CONSTRUCTION PLANS
FOR
VILLAGE AT LORSON RANCH
STREET AND STORM SEWER
CONSTRUCTION PLANS

**VILLAGE AT LORSON RANCH
STREET AND STORM SEWER PLANS
COVER SHEET**

V1_street-storm plans.pdf Markup Summary

STREET PLANS
STREET AND STORM SEWER PLANS
CARRIAGE MEADOWS DRIVE TURN LANE

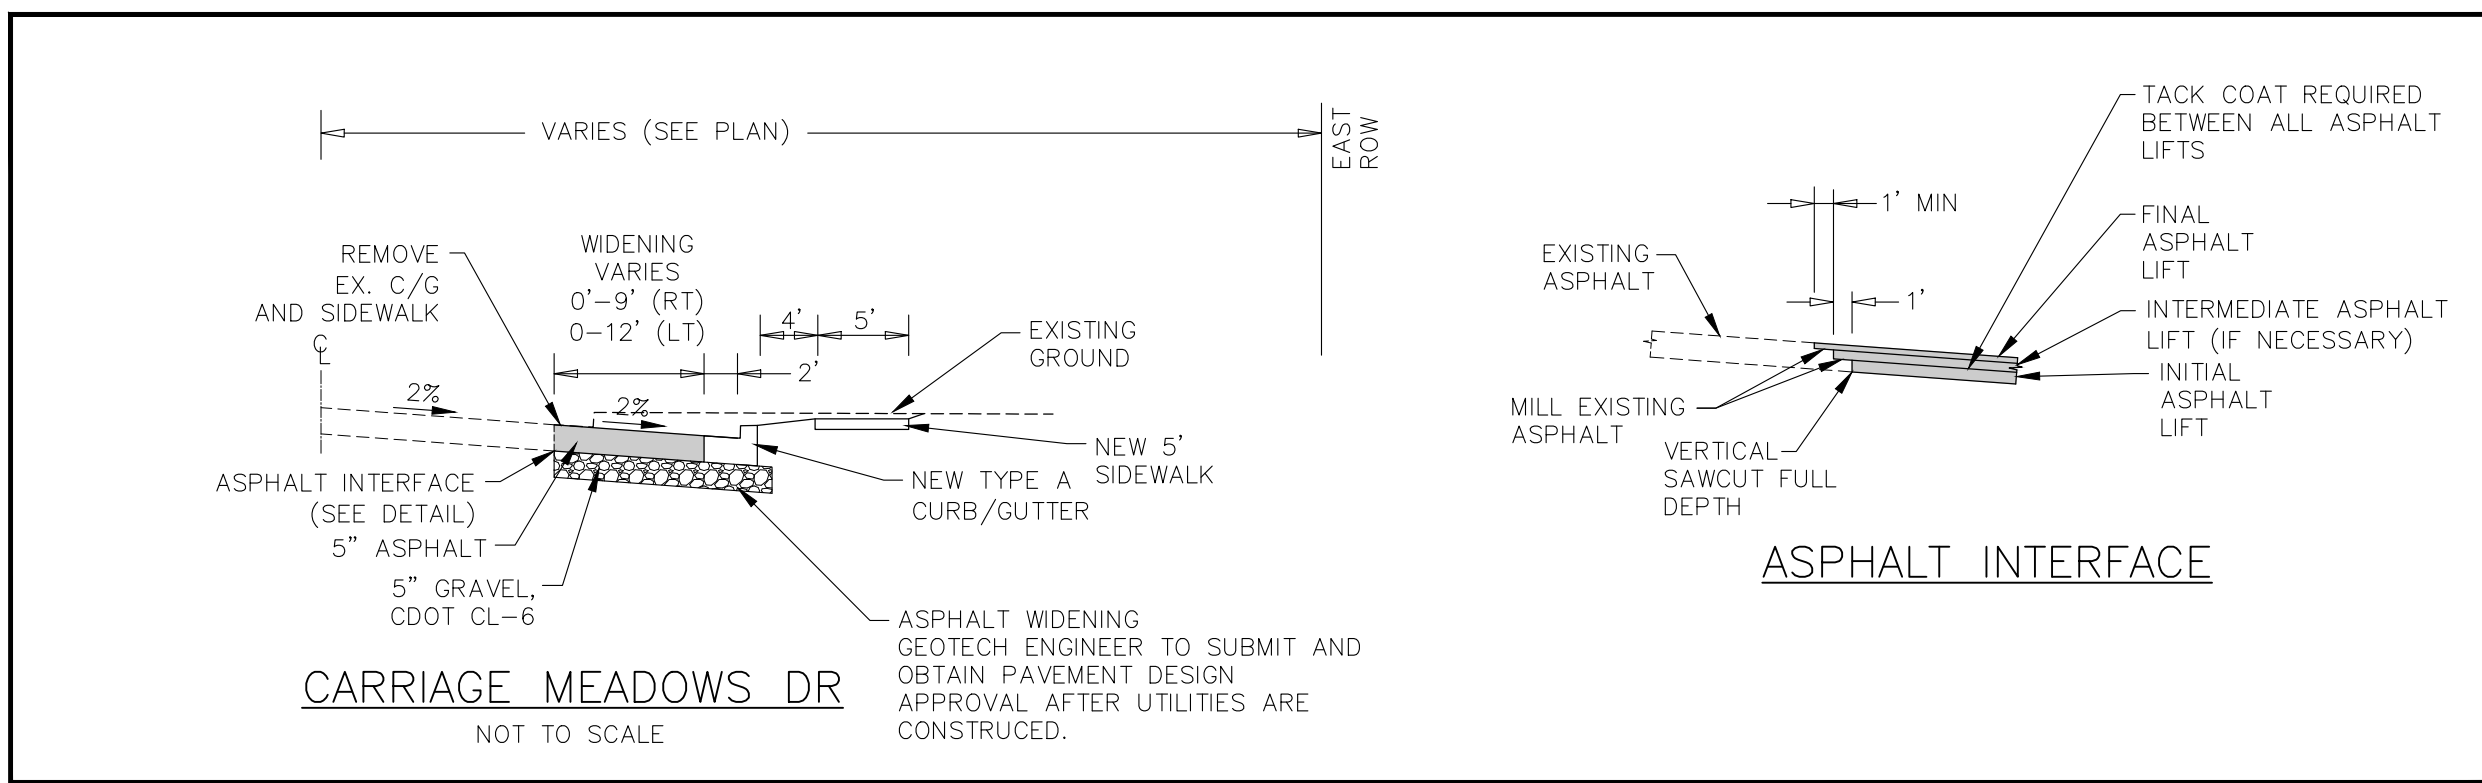
Channelization islands will need to be installed with signals at the intersection. Please set up a meeting with staff to discuss design.
